LAND USE APPLICATION COMPLETENESS REVIEW

Second Review Comments

Subject Property: 1105 Front Street NE

Reference Nos.: 24-106451-PLN (Class 3 Site Plan Review, Tentative Subdivision Plan, Class 1 & 2 Adjustment, Class 2 Driveway Approach Permit)

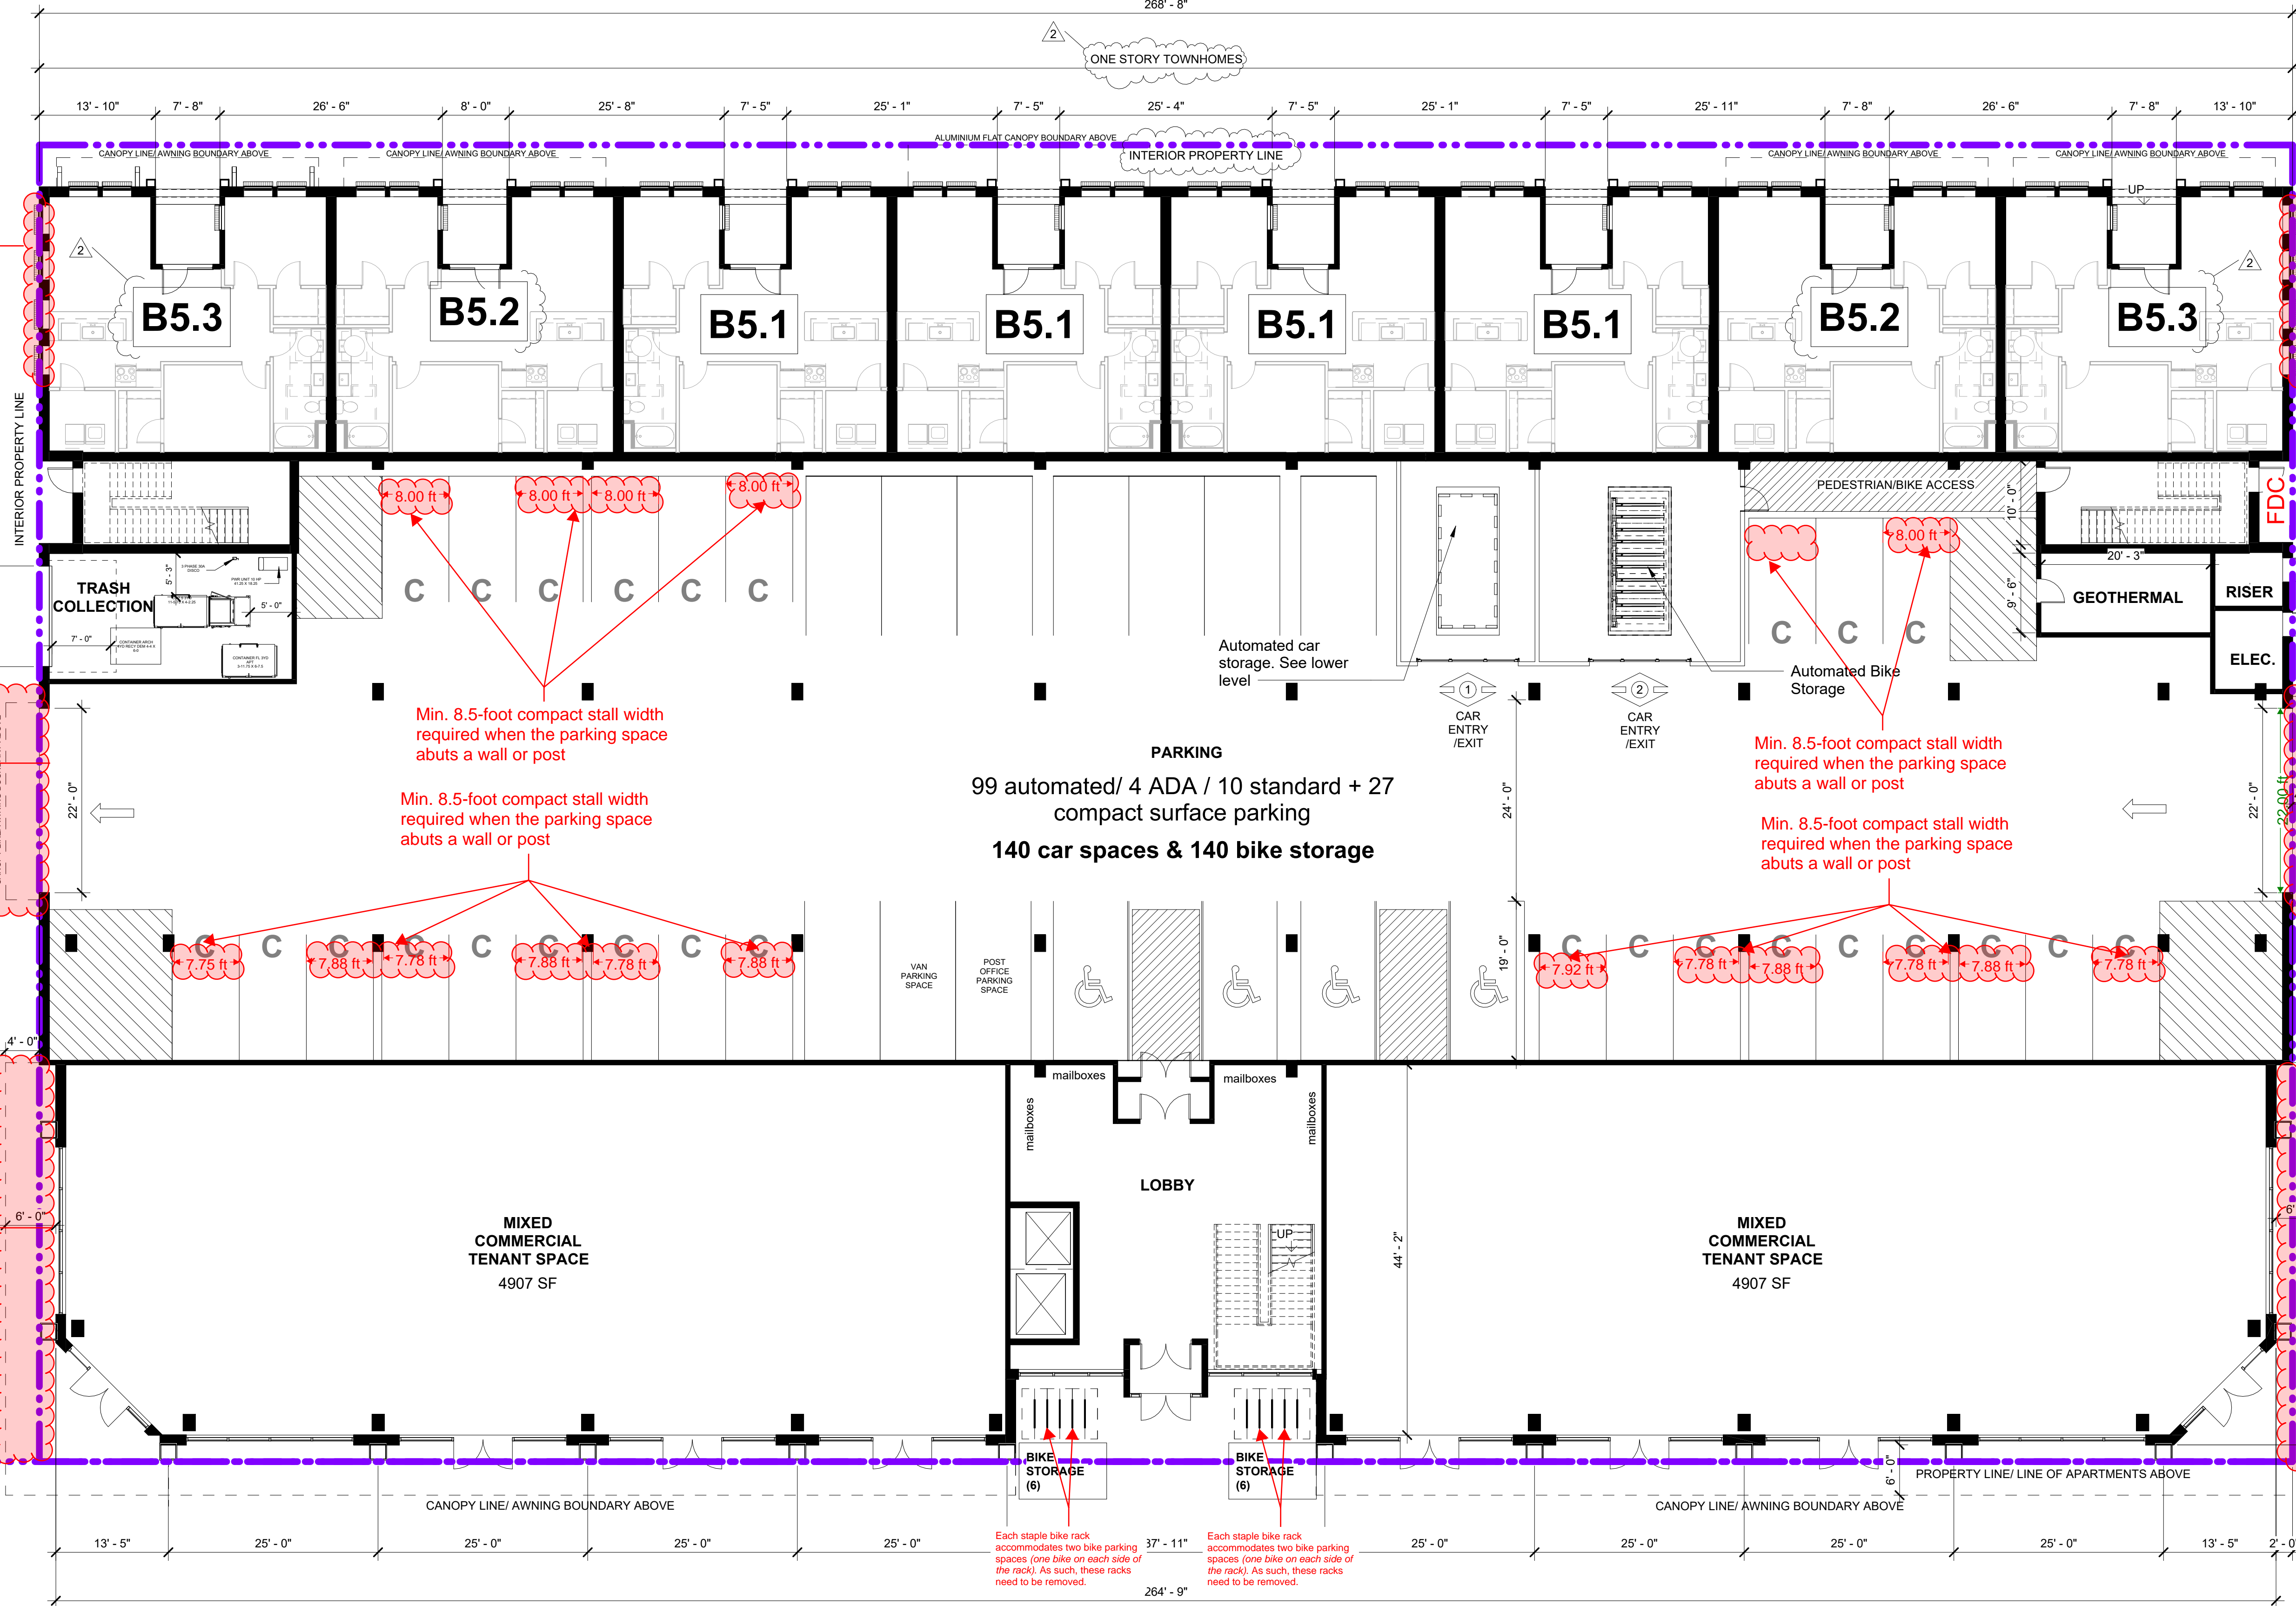
It appears that portions of the building project over the property line. Confirmation required if this will be allowed under the building code.

If so, an easement will be required.

It appears that portions of the building project over the property line. Confirmation required if this will be allowed under the building code.

If so, an easement will be required.

Canopy projects across property line. Confirmation required if this will be allowed under the building code.

If so, an easement will be required.

Min. 8.5-foot compact stall width required when the parking space abuts a wall or post

Min. 8.5-foot compact stall width required when the parking space abuts a wall or post

Min. 8.5-foot compact stall width required when the parking space abuts a wall or post

Min. 8.5-foot compact stall width required when the parking space abuts a wall or post

Canopy projects across property line. Confirmation required if this will be allowed under the building code.

If so, an easement will be required.

Canopy projects across property line. Confirmation required if this will be allowed under the building code.

If so, an easement will be required.

Canopy projects across property line. Confirmation required if this will be allowed under the building code.

If so, an easement will be required.

Each staple bike rack accommodates two bike parking spaces (one bike on each side of the rack). As such, these racks need to be removed.

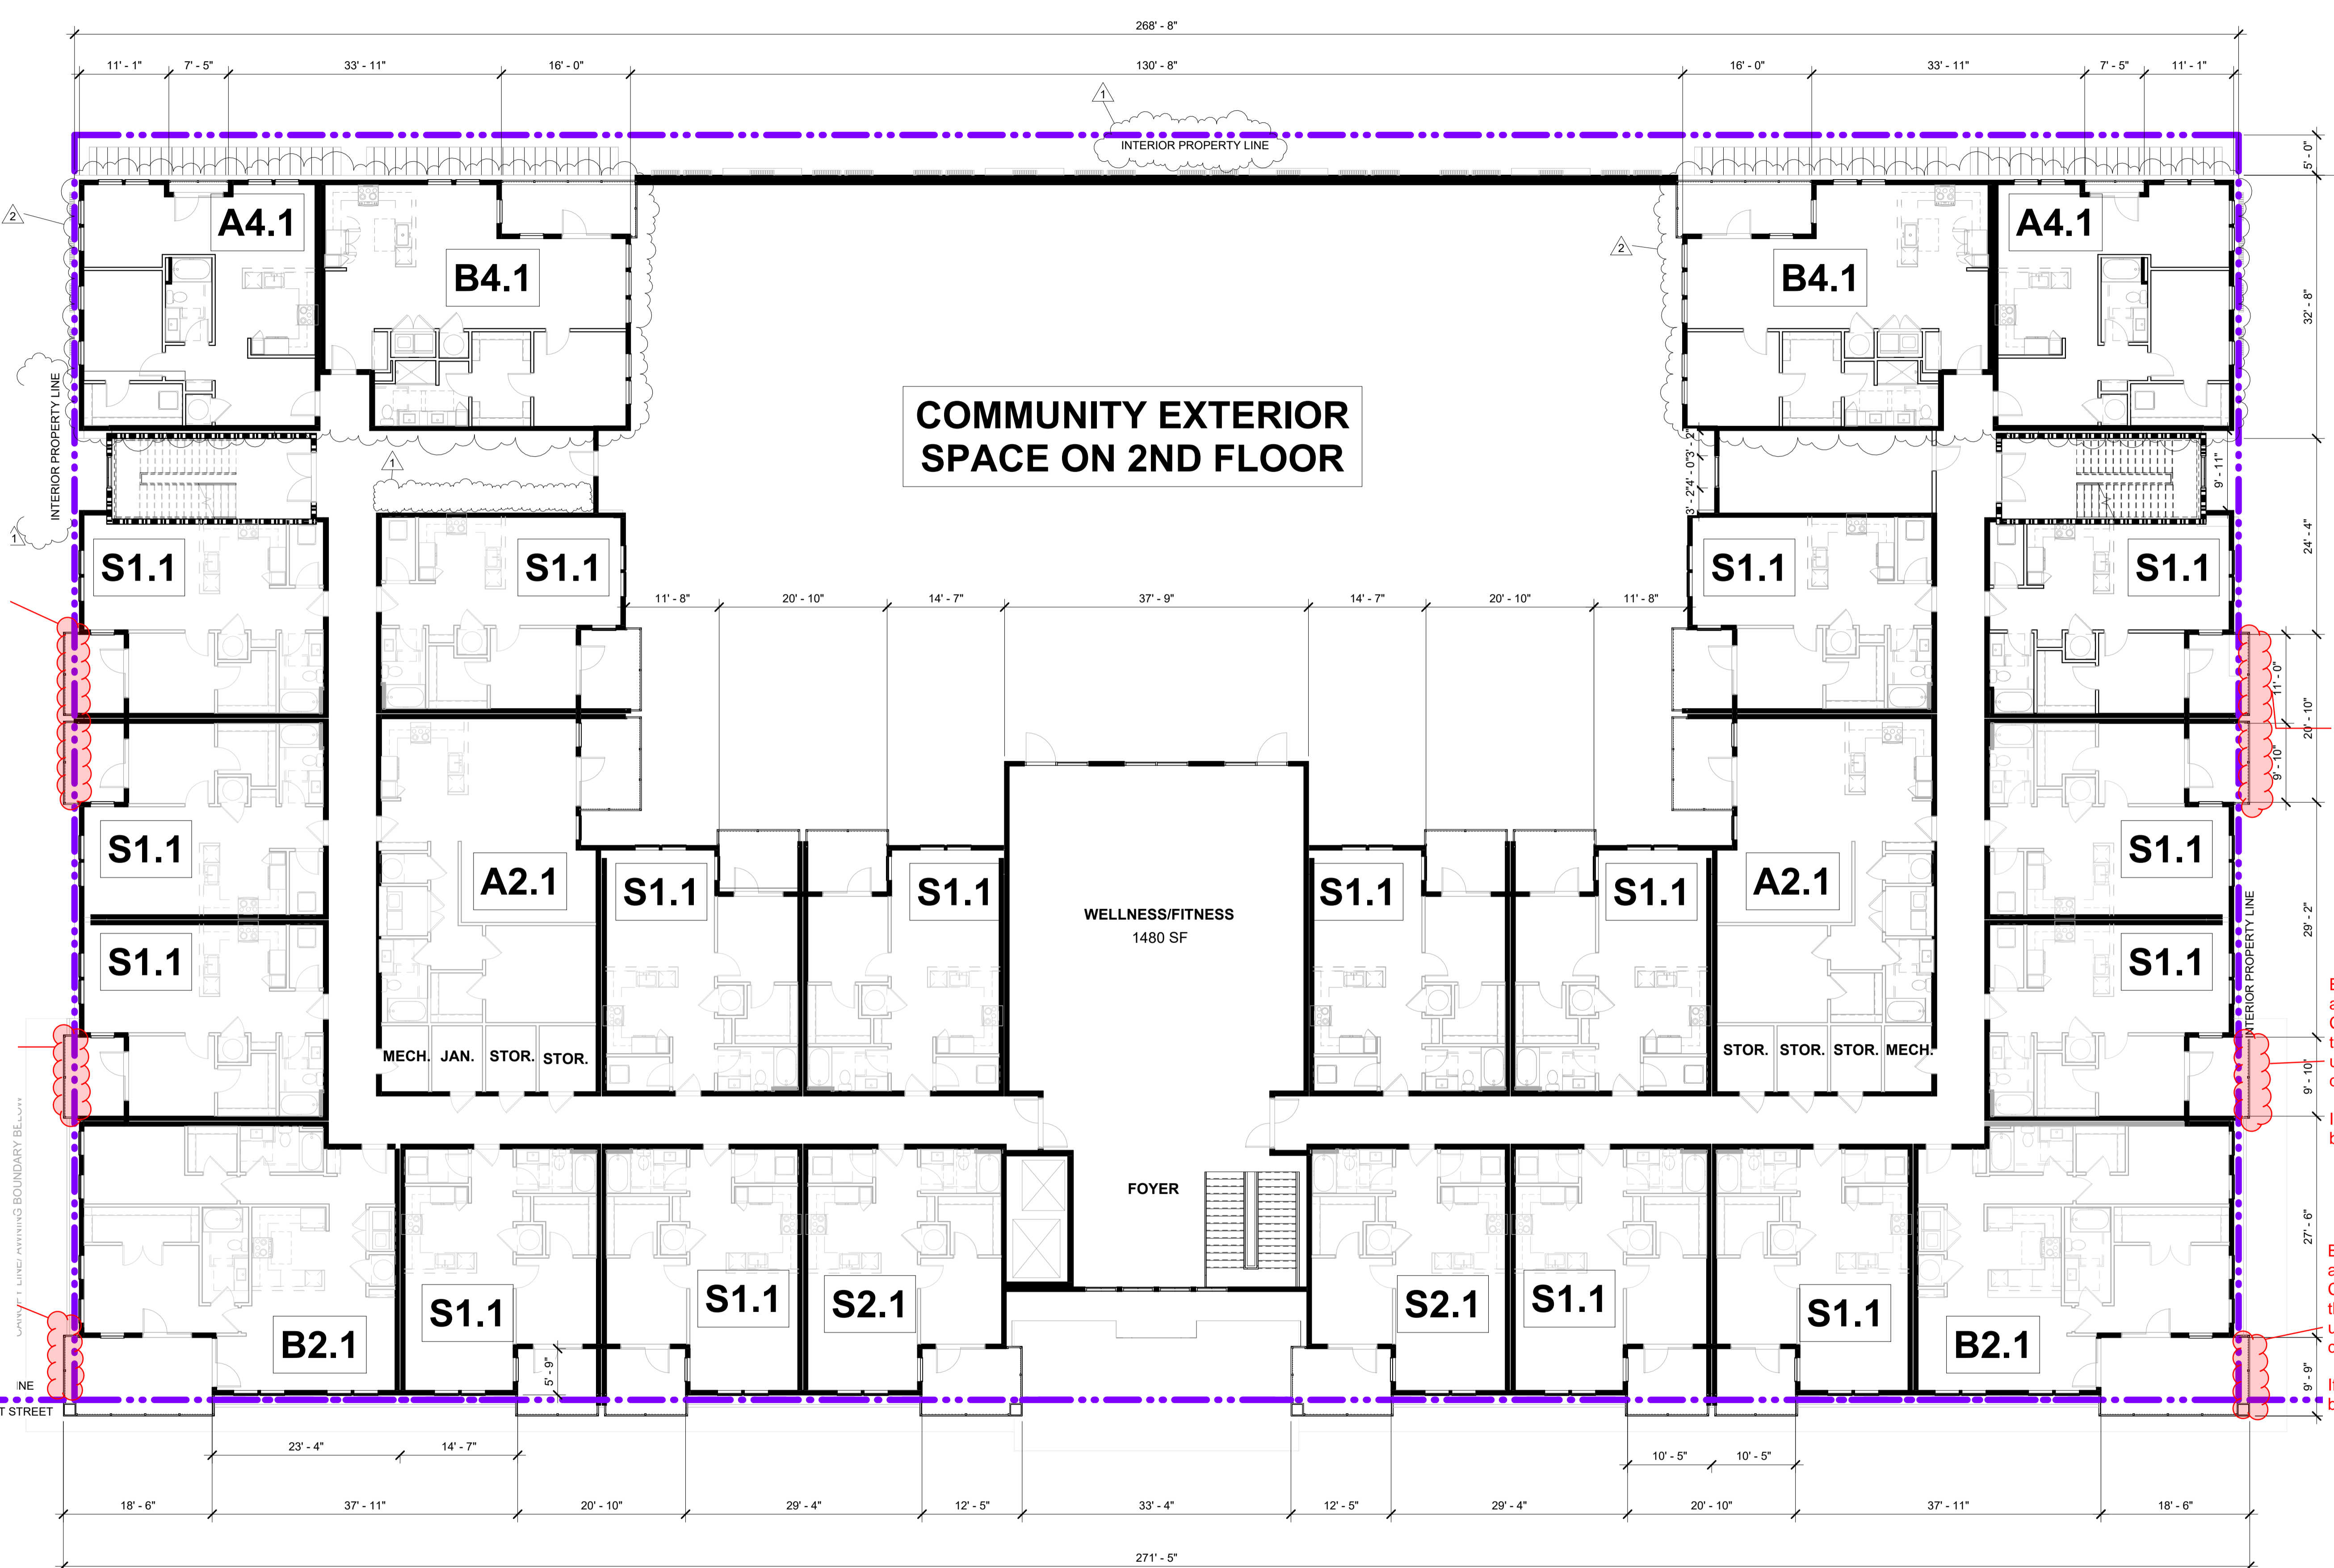
Balconies project across property line. Confirmation required if this will be allowed under the building code.
If so, an easement will be required.

Balcony projects across property line. Confirmation required if this will be allowed under the building code.
If so, an easement will be required.

Balcony projects across property line. Confirmation required if this will be allowed under the building code.
If so, an easement will be required.

Balconies project across property line. Confirmation required if this will be allowed under the building code.
If so, an easement will be required.

Balcony projects across property line. Confirmation required if this will be allowed under the building code.
If so, an easement will be required.

Balcony projects across property line. Confirmation required if this will be allowed under the building code.
If so, an easement will be required.
